Docket Number:	19-AAER-01
Project Title:	Spray Sprinkler Bodies
TN #:	230195
Document Title:	Final Statement of Reasons
Description:	Spray Sprinkler Bodies
Filer:	Sean Steffensen
Organization:	California Energy Commission
Submitter Role:	Commission Staff
Submission Date:	10/15/2019 9:21:06 AM
Docketed Date:	10/15/2019

**FINAL STATEMENT OF REASONS**

Spray Sprinkler Bodies
Docket No. 19-AAER-01
Z # 2019-0416-02

B2

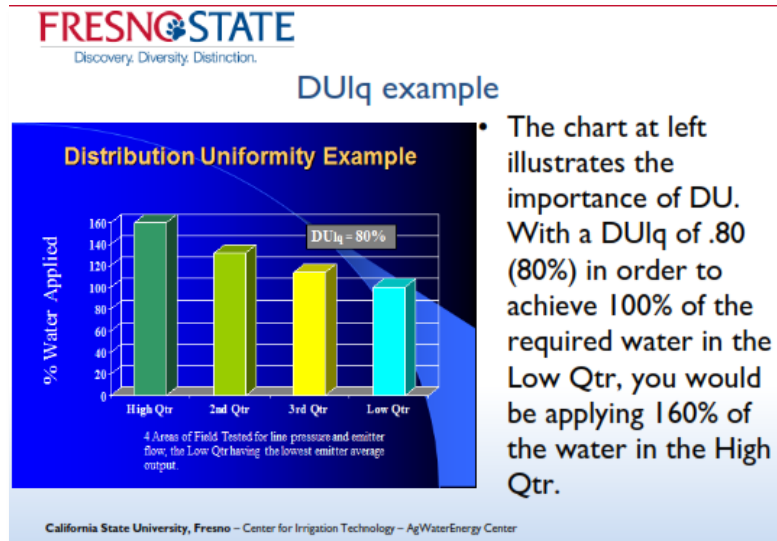
This system has been tested by the Center for Irrigation Technology (CIT) at Fresno State, and there is an attachment that summarizes how digital heads use 40-50% less water.
